**NEW RIVER CHANNELIZATION
GRAND AVENUE TO SKUNK CREEK**

LETTER OF MAP REVISION SUBMITTAL

IN REPLY REFER TO:
Case No.: 07-09-0452P

Follows Conditional Case No.: 05-09-1046R
Community: City of Peoria, AZ
Community No.: 040050
FIRM Panel Affected: 04013C1610 J and
04013C1630 H

FLOOD PROFILES
 NEW RIVER
 MAR 09 2007

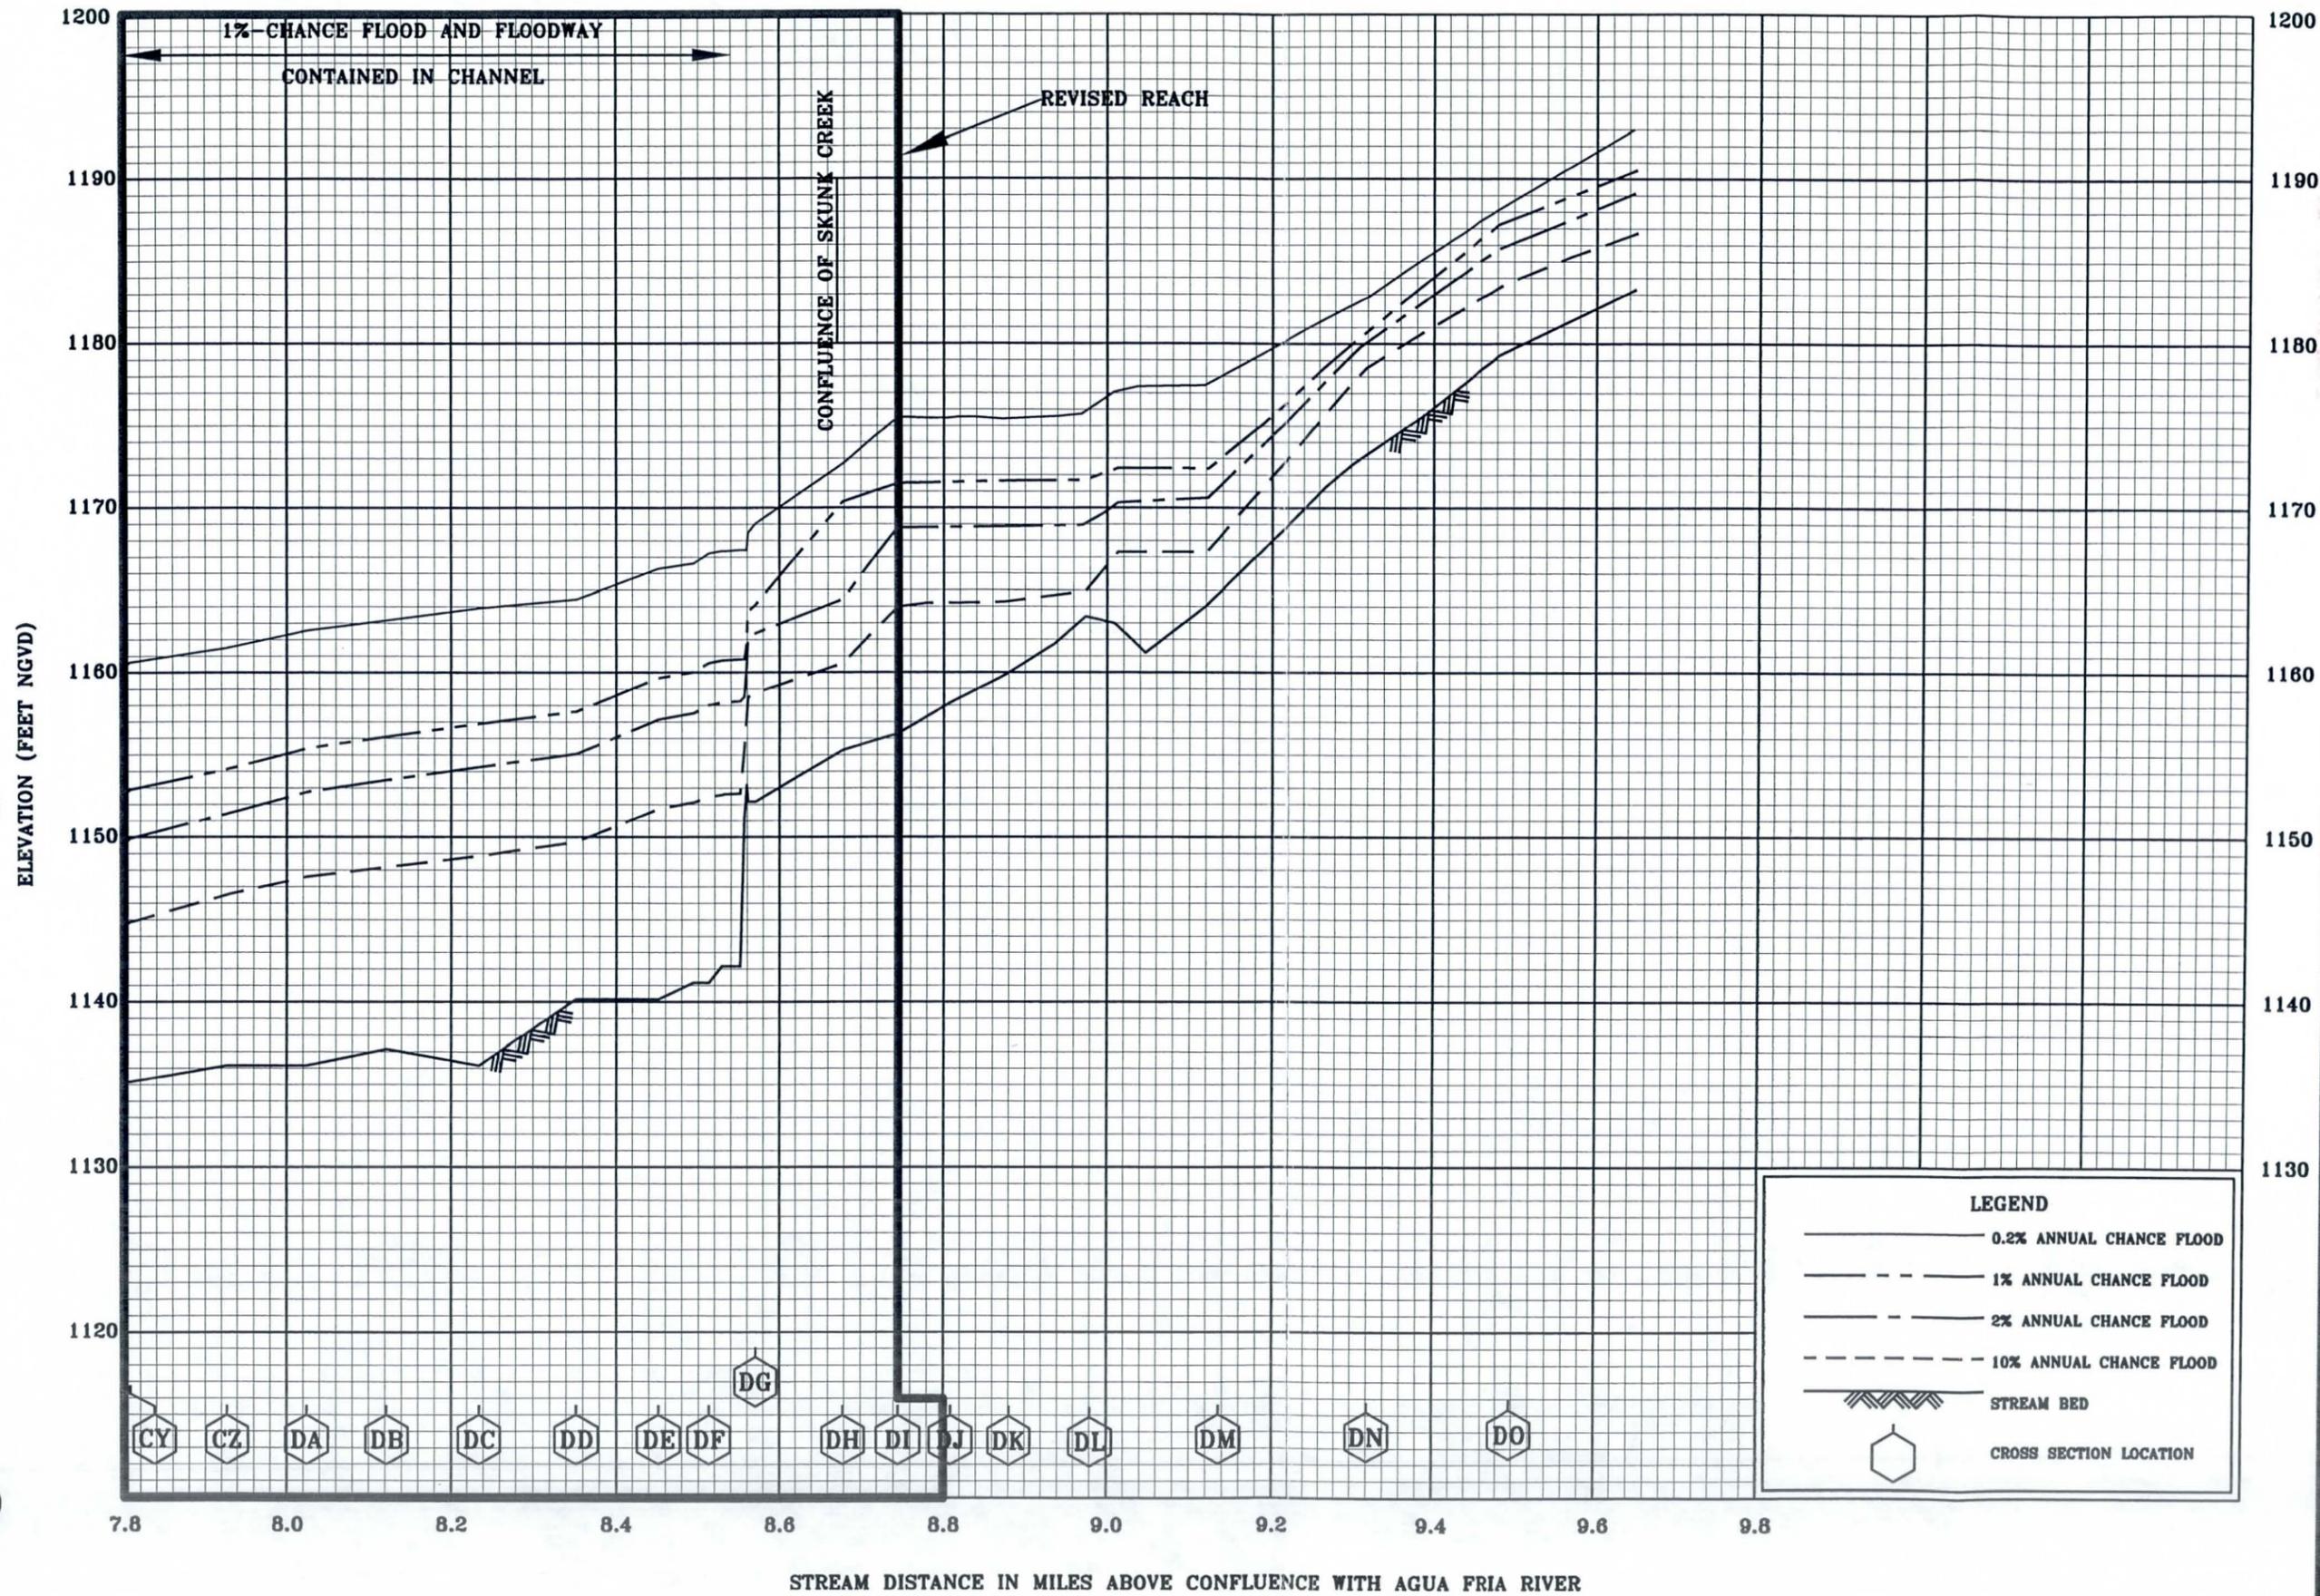
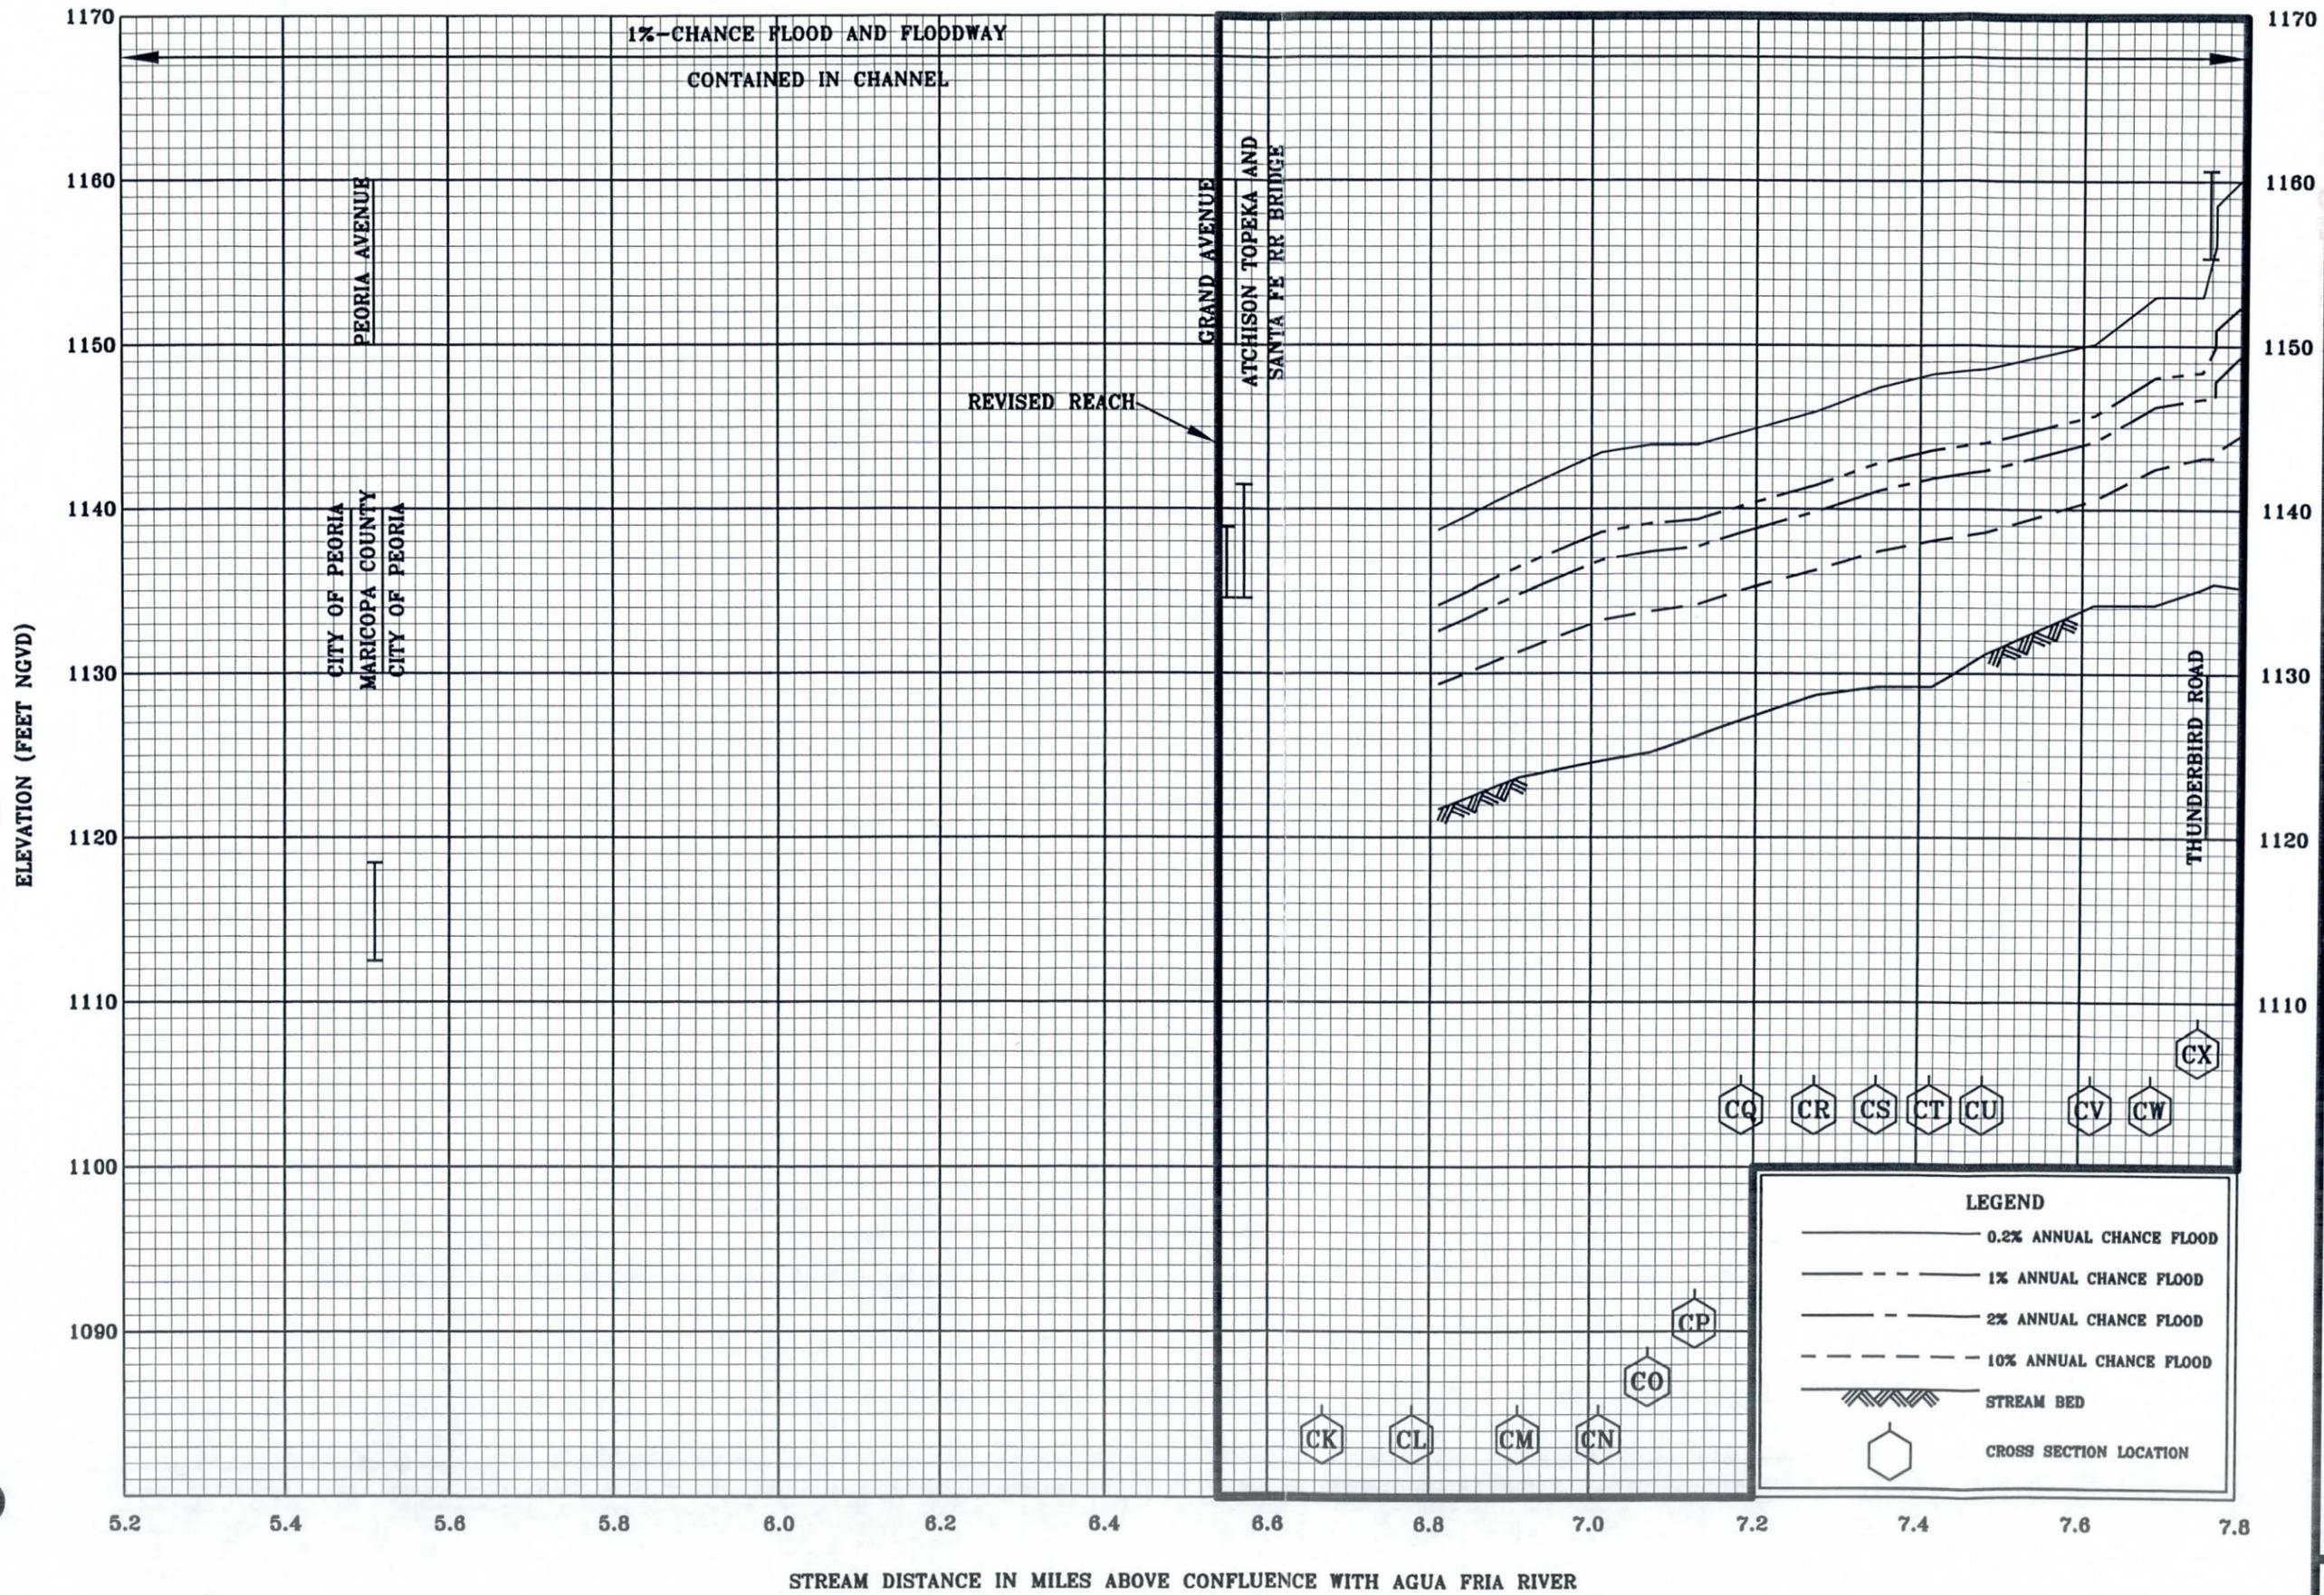
A hydraulic analysis was performed to incorporate new topographic data and channelization for New River from approximately 1,150 feet upstream of Grand Avenue to approximately 5,200 feet upstream of Thunderbird Road and has resulted in a revised delineation of the regulatory floodway, a decrease in SFHA width, and decreased BFEs for New River. The aforementioned channelized portion of New River contains the base flood. The table below indicates existing and modified BFEs for selected locations along the affected lengths of the flooding source(s) cited above.

Location	Existing BFE (feet)*	Modified BFE (feet)*
Approximately 1,150 feet upstream of Grand Avenue	1,137	1,134
Approximately 4,700 feet upstream of Thunderbird Road	1,170	1,169

FLOODING SOURCE	LOCATION OF REFERENCED ELEVATION	BFE (FEET NGVD 29)		MAP PANEL NUMBER(S)
		EFFECTIVE	REVISED	
New River	approximately 1,150 feet upstream of Grand Avenue	1,137	1,134	04013C1610 J
	approximately 4,420 feet upstream of Thunderbird Road	1,170	1,169	04013C1630 H
